Proposed Changes to the England Coast Path at Nethertown and Sellafield, Cumbria

Natural England's Variation Report to the Secretary of State

Coastal Access Variation Report VR7
26th June 2019

Map VR7a Nethertown railway station

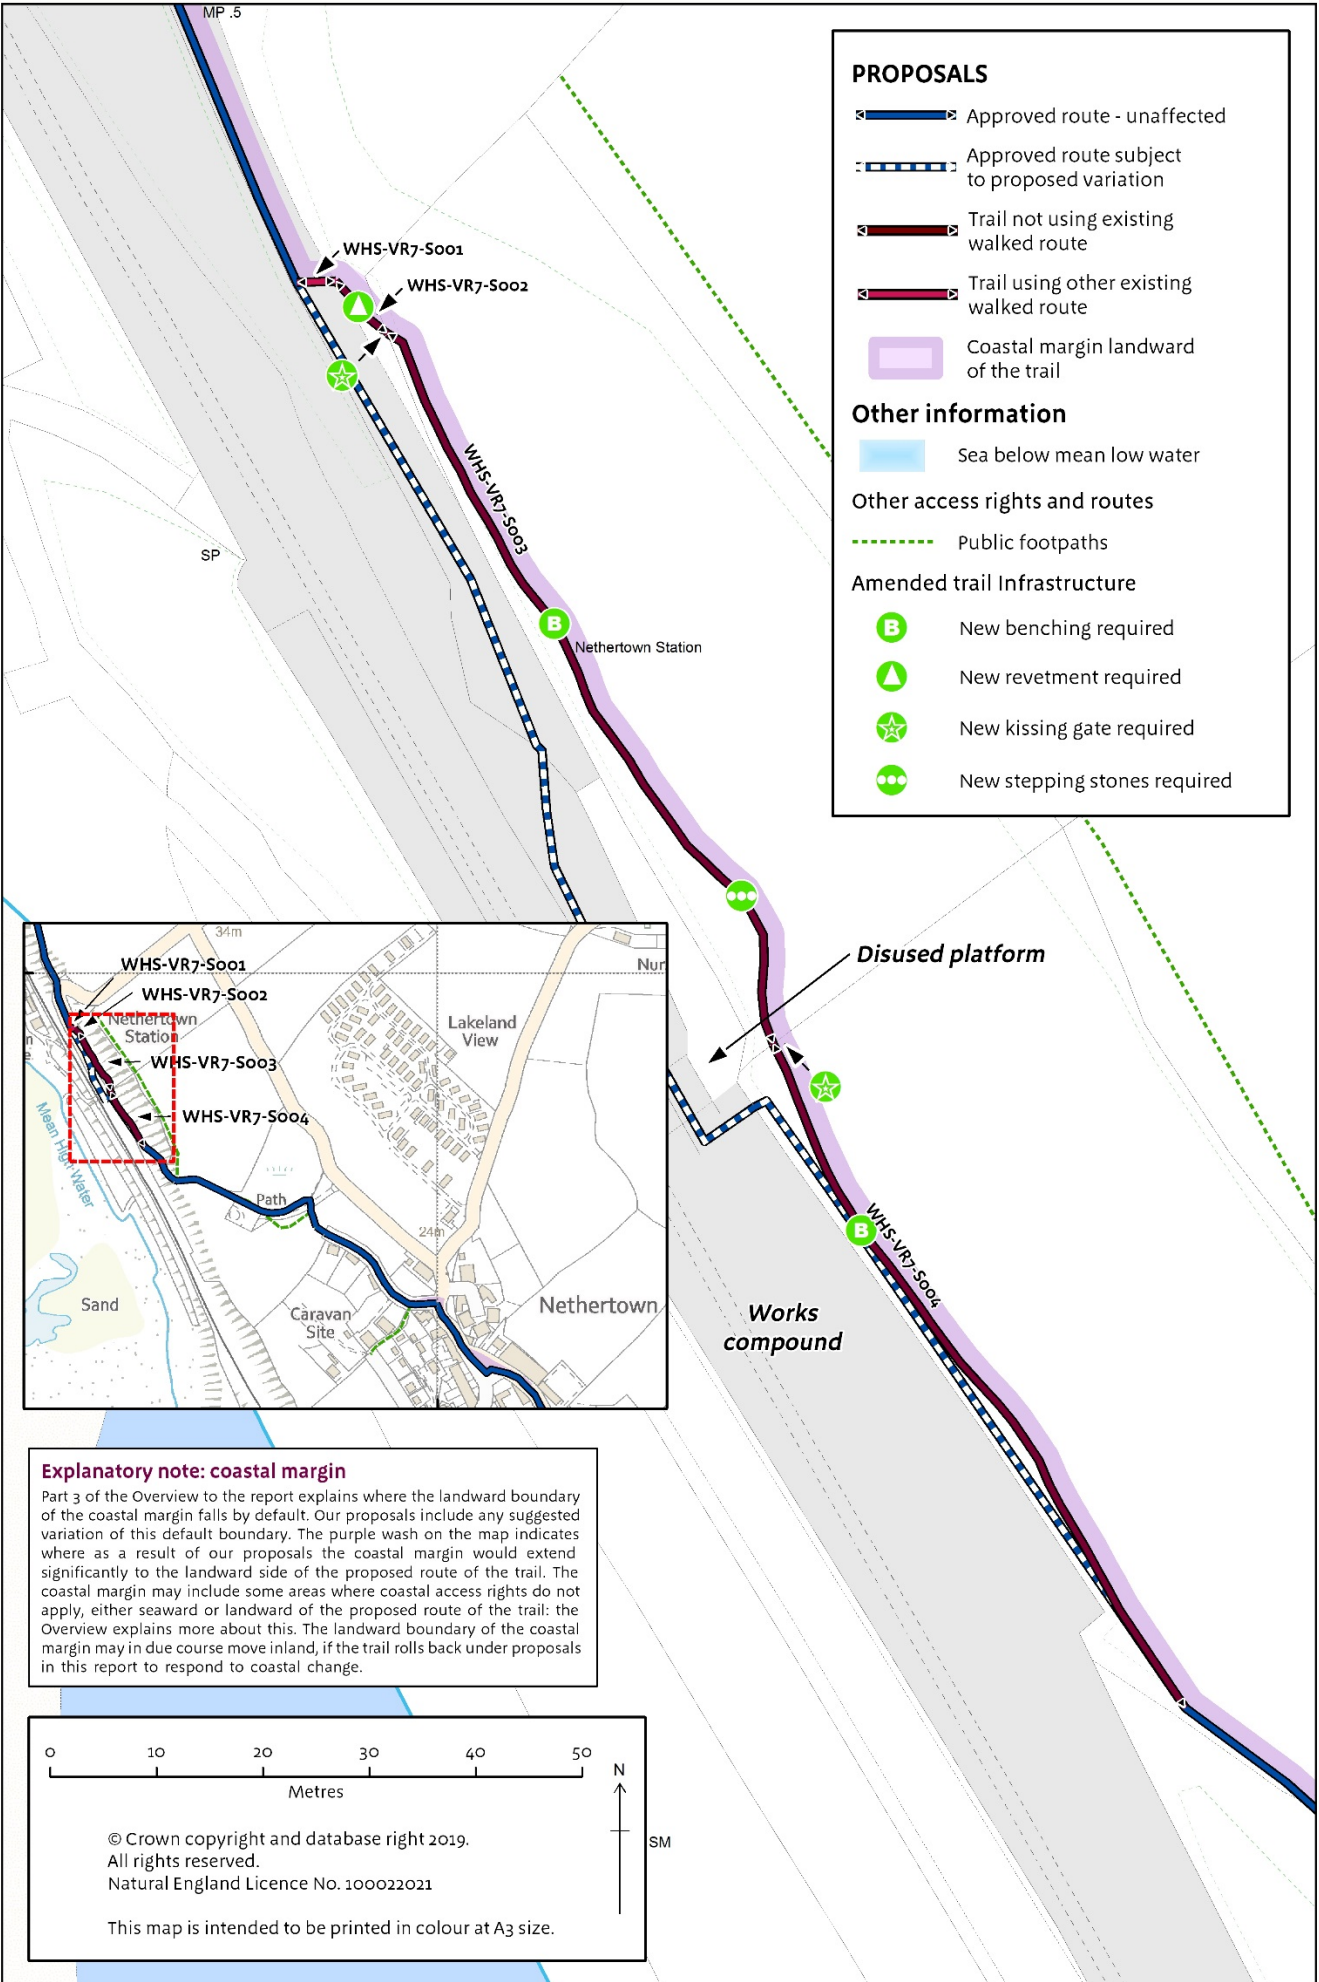
2.1.1 Network Rail (NR) supported the route we originally proposed, at and around Nethertown station. On that basis it was approved by the Secretary of State. The proposed route lay immediately landward of the boundary fence around NR's works compound, adjacent to the southern end of the railway platform at the landward side of Nethertown station. It entered NR land at the north-eastern corner of this compound, before passing along the disused platform. We proposed this route originally on the grounds that it met all the main requirements within the approved Coastal Access Scheme and was an existing walked route (thus apparently avoiding the need to create a new route in the area).

2.1.2 However, there has been some change of situation locally. During more recent discussions with NR around trail establishment, it has become apparent that:

- The fence on the landward side of the works compound has been replaced on a slightly different alignment, meaning that the approved route now sits partially within the compound rather than entirely landward of it.

- This area, next to the disused station platform, is now more actively used as a fenced NR storage compound, and contains various hazards on or adjacent to the approved route that were not previously present.

- NR is now taking a more risk averse approach to access through the compound and along the raised, disused station platform, which is now used for NR vehicle access to the adjacent works compound. NR would now insist on expensive new infrastructure such as safety barriers being installed there as a condition of any route establishment. In fact, there is insufficient space on the disused platform (and above the underpass in particular) to accommodate the ECP alongside any vehicle movements, whilst maintaining public safety. As a result, NR feel the approved route as a whole is incompatible with their operational and safety requirements.

2.1.4 A more pleasant potential route is available along field edges just inland of the station and compound area. The most southerly part of this proposed variation seeks to reposition the trail so that it remains on the landward side of the works compound (accommodating NR's recent realignment of the boundary fence). The more northerly part of the proposed variation would then continue on this field-edge route, just landward of the disused station platform, underpass and minor access road. The proposed variation has been discussed with the affected landowners, and is broadly accepted as the most appropriate of the available options.

2.2.1 Our proposal (see map VR7a) is to re-route the path to the landward side of the current compound fence, disused station platform and underpass, at the bottom of the coastal slope (proposed route sections WHS-VR7-S001 to WHS-VR7-S004). The realigned trail would extend to a length of 162 metres, at a maximum of 15 metres landward of the approved route line and would still pass within 50 metres of the station entrance (allowing for easy access to the station as required).

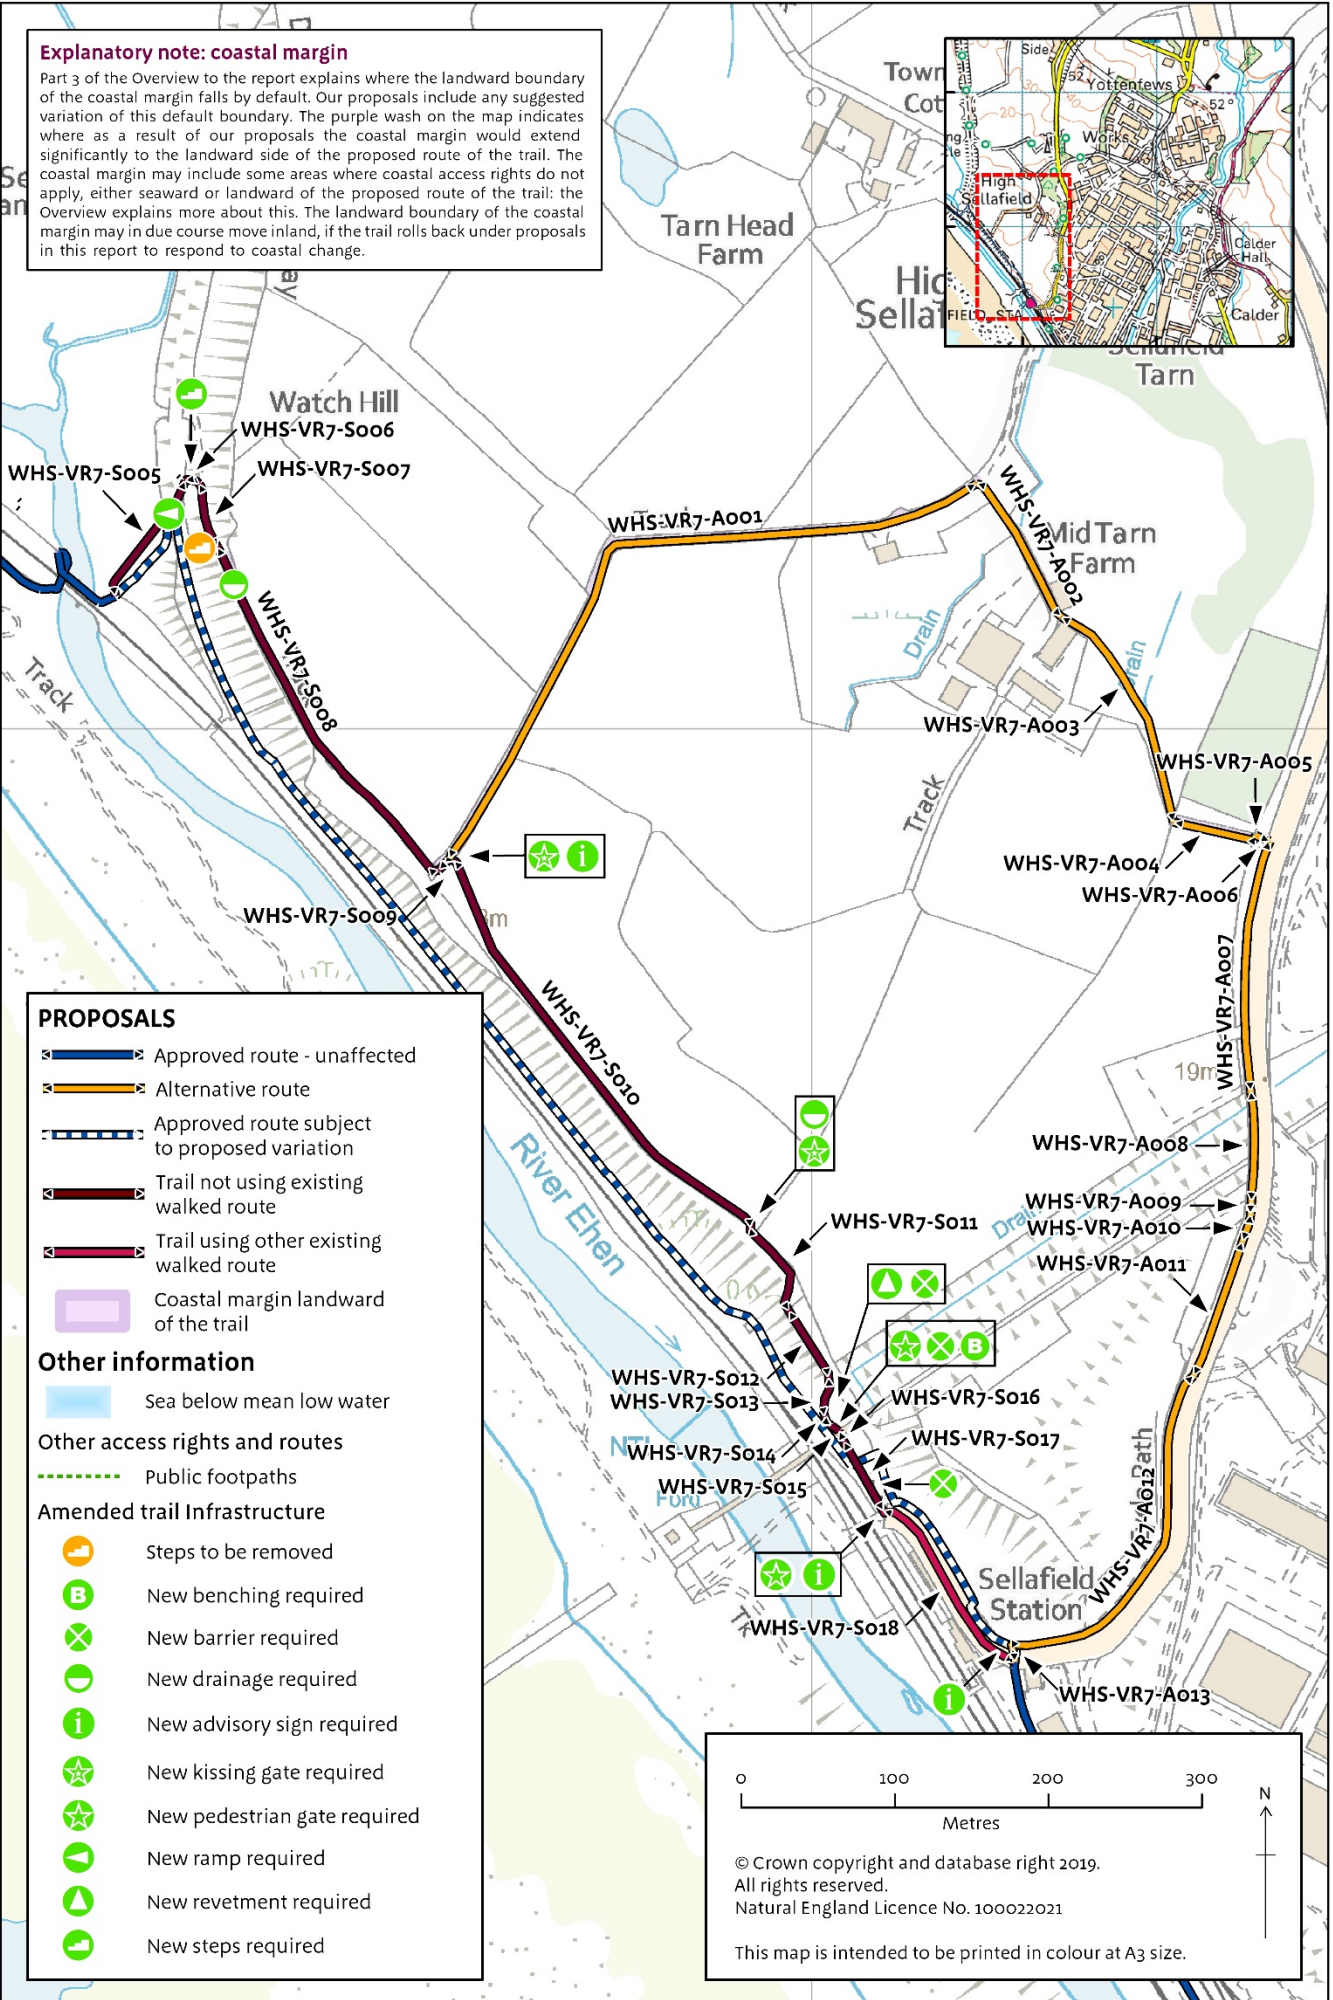
3.1.1 Our original alignment of the ECP in this area, as approved by the Secretary of State, reflected an offer at the time by NR to remove a disused railway siding in order to create a sufficiently wide corridor within which the path could pass and could be fenced off from the active railway line. NR undertook to install this fencing and to undertake themselves the removal of the siding. These works would have segregated the path from the land used for the purposes of a railway, and thereby avoided the path corridor being regarded as excepted land for the purposes of CROW access rights.

3.1.2 However under its new local representation (see above), NR now advises that the siding is being returned to operational use and cannot be removed, which means there is not physically space for the ECP to pass through the corridor in question. Neither are NR willing to provide the required new fence, even if there had been room to do so. The land in question would therefore reasonably be regarded as part of the land used for the purposes of the railway, and therefore excepted land.

3.1.5 In summary, the route can no longer pass through the ‘railway corridor’ as originally agreed with NR; but it may now pass on the seaward side of the former development site, along a preferred alignment on or close to the original line of an existing promoted route. In the circumstances we are proposing the variation of the approved route onto the latter alignment, as shown on map VR7b.

3.2.1 Our proposal (see map VR7b) is, from north to south, to re-route the path between the Ehen viaduct and Sellafield station, including an alternative route available when the main trail may occasionally be closed for operational reasons (see 3.2.10 to 3.2.14 below). The realigned main trail would extend to a length of 1.08km, at a maximum of 50 metres landward of the approved route.

3.2.2 The proposed route would cross the common from the railway viaduct over the River Ehen, on a slightly different route to the former Cumbria Coastal Way, to avoid using the existing but disused steep flight of steps (proposed route sections WHS-VR7-S005 to WHS-VR7-S007). It would then follow a strip of common land along the top of the slope (section WHS-VR7-S008), before entering an agricultural field at NY017039. Before reaching the Sellafield site itself, the path will exit the field to drop gradually down the slope, passing directly underneath the pipe bridge, then in a

corridor past an existing works compound and on to Sellafield station, where it will join the previously approved route on the existing cycle path to Seascale.

Directions Map VR7c Sellafield

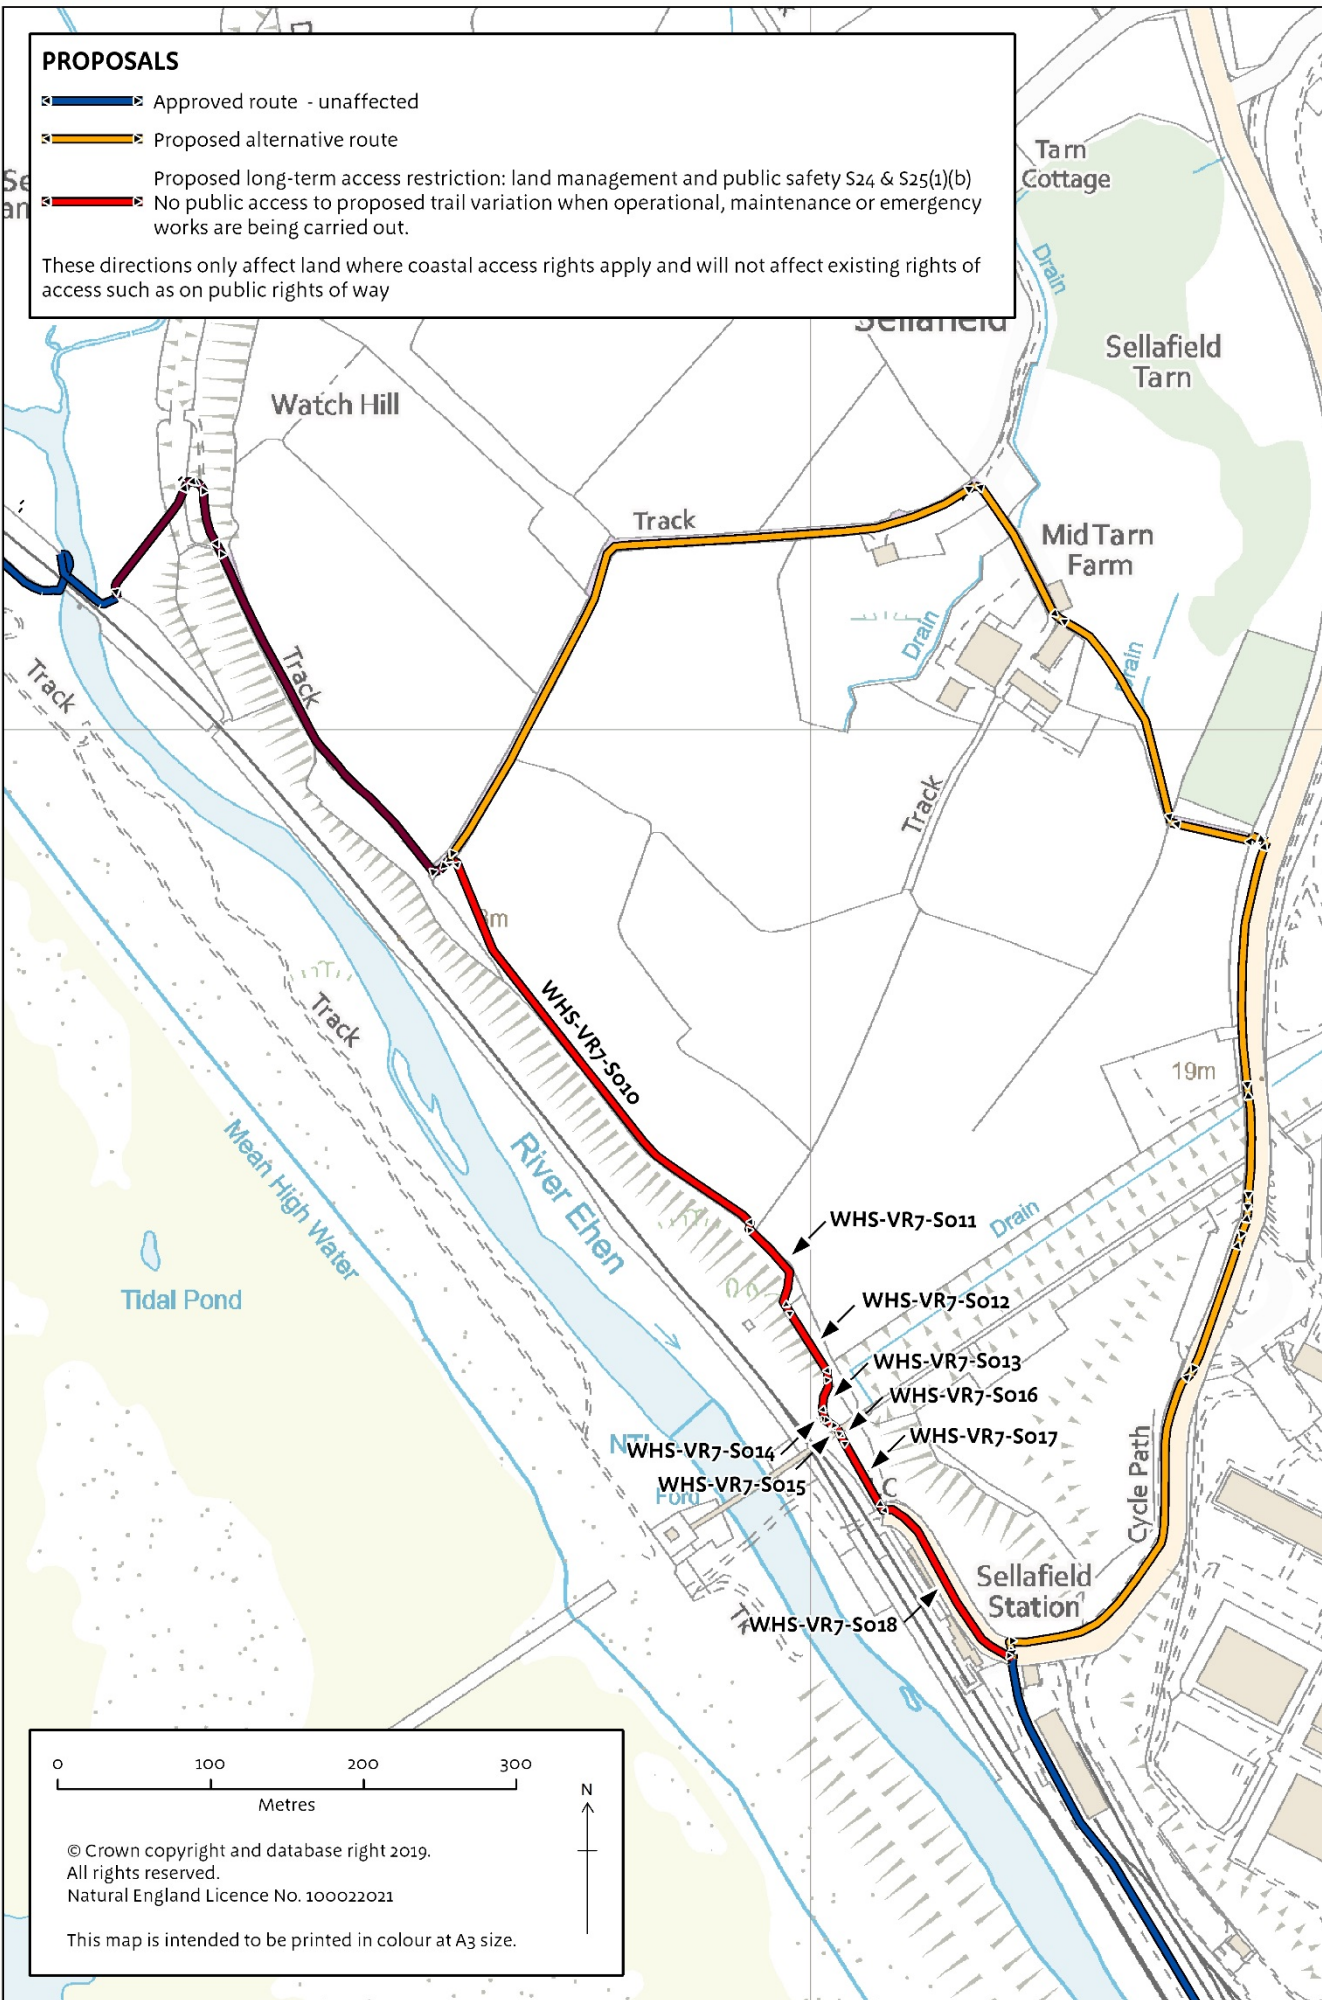
3.2.12 Access to route sections WHS-VR7-S010 to WHS-VR7-S018 is to be excluded by outline direction, under s24 and s25(1)(b) of the Countryside and Rights of Way Act (2000) at times when this is required to enable short-term emergency, maintenance or operational works to be carried out (see map VR7c).
